Regulation No. 46 (Devices for indirect vision)

### **Proposal for amendments to Regulation No. 46 (Devices for indirect vision)**

**Submitted by the expert from Japan \***

The text reproduced below was prepared by the expert from Japan to introduce requirements allowing the installation of systems controlling the access of passengers on board. This document is based on informal document GRSG-103-13 distributed during the 103rd session of the Working Party on General Safety Provisions (GRSG). The modifications to the existing text of the Regulation are marked in bold characters.

Figure 3(a)

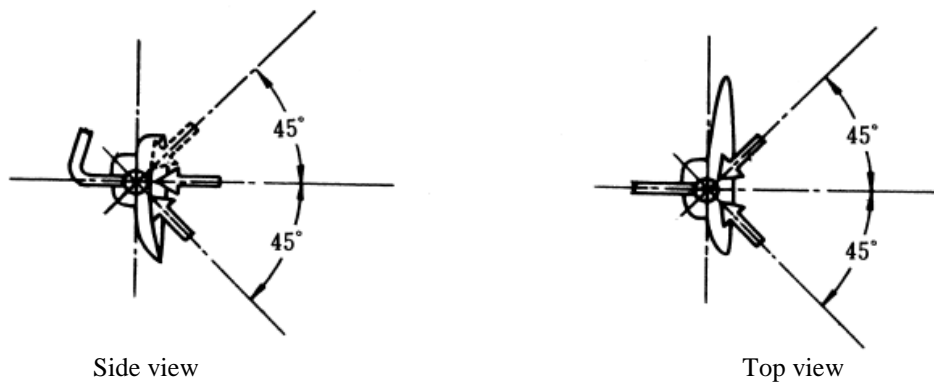
**In the case of the exterior mirror, apply a rearward force in a direction parallel to the vehicle centre line, to the centre of the rear-view mirror's direction-swivel section (or to the centre of the outermost mirror's direction-swivel section if more than one mirror is supported by the same mounting section, or to the centre of the mirror body if there is no direction-swivel section). However, if the centre of the rear-view mirror's direction-swivel section is located inside the vehicle's outermost side in the vicinity of the mirror mounting area, or that centre is located at a height of more than 2.0 m above the ground, the force may be applied to any part of**

In the case of the interior mirror, apply a forward force in each of the following directions, to the centre of the rear-view mirror's direction-swivel section (see Figure 3(a)):

- (a) Direction parallel to the vehicle centre line;
- (b) Directions  $45^\circ$  to the left and right of the vehicle centre line on the horizontal plane; and
- (c) Direction  $45^\circ$  upward or downward of the horizontal line on the vertical plane parallel to the vehicle centre line.

Figure 3(b)

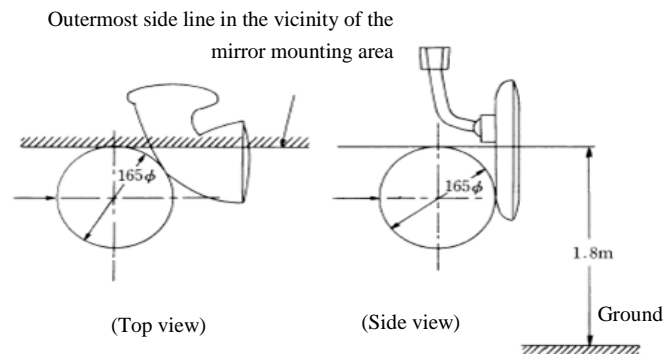
In the case of the exterior mirror, place a 165 mm diameter cylinder in such a way that the exterior of the cylinder comes in contact with the vehicle's outermost side line in the vicinity of the mirror mounting area, or the line drawn at a height of 2.0 m above the ground. Apply a rearward force in a direction parallel to the vehicle centre line, to the cylinder centre line (see Figure 3(b)).

Figure 3(c)

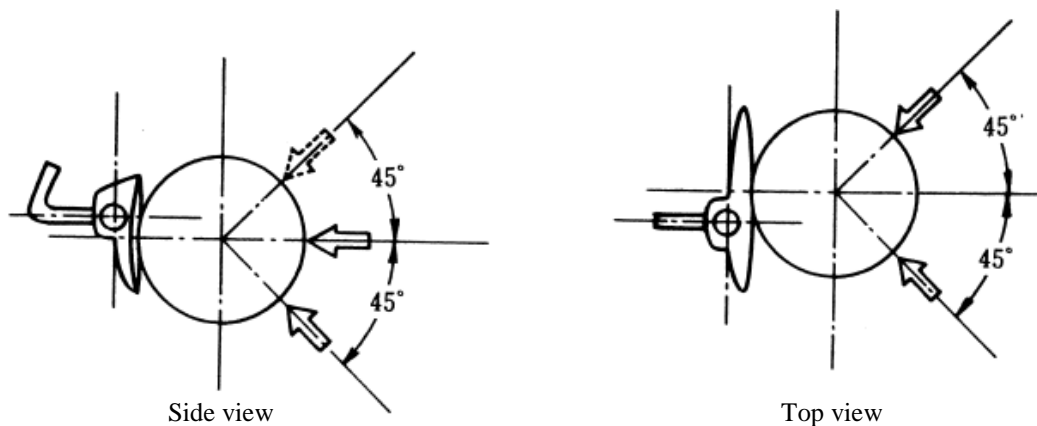
In the case of the interior mirror, place a 165 mm diameter spherical object in such a way that it comes in contact with the mirror surface centre, and apply a forward force in each of the following directions, to the spherical object centre (see Figure 3(c)):

- (a) Direction parallel to the vehicle centre line;
- (b) Directions  $45^\circ$  to the left and right of the vehicle centre line on the horizontal plane; and
- (c) Direction  $45^\circ$  upward or downward of the horizontal line on the vertical plane parallel to the vehicle centre line.

Figure 11

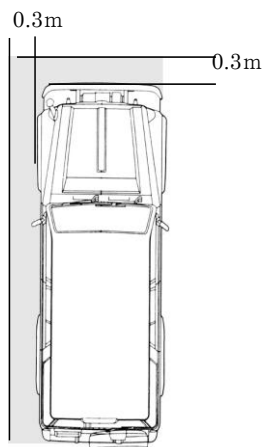
**In vehicles of category M, a cylinder with a diameter of 0.3 m and height of 1.0 m that is in contact with the vehicle's front side and the lateral side on the passenger's side shall be partially visible using direct field of vision or any mirror including the surveillance mirror (see Figure 11). In this case, the eye-points in the direct field of vision are determined in Annex III. However, the blind area created by the A-pillar or exterior rear-view mirror as specified in Annex IV is excluded. If the field of vision cannot be achieved using these options, it may be achieved through installing a camera-monitor device, provided that it is easy to control the device to display images.**

Figure 1

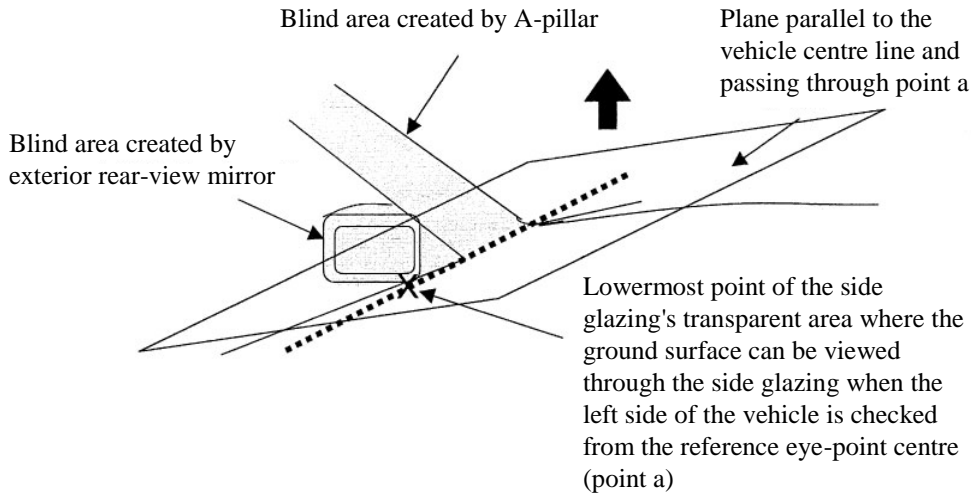
The range of the blind area created by the A-pillar or exterior rear-view mirror in paragraph 15.2.4.10. shall be an area that meets the following formula. In this case, if there are more than one blind area, each blind area shall meet the conditions of the formulae.

$$X \leq 0.292 \cdot L - 0.203$$

X (m): is the limit of the excluded area, i.e. the distance between the centre of a cylinder in contact with the front edge of the

blind area and the centre of a cylinder in contact with its rear edge.

**L (m):** is located inside the blind area created by the A-pillar or exterior rear-view mirror. Distance between the rear edge of a cylinder in contact with the rear edge of the blind area and the front edge of the rear wheel.
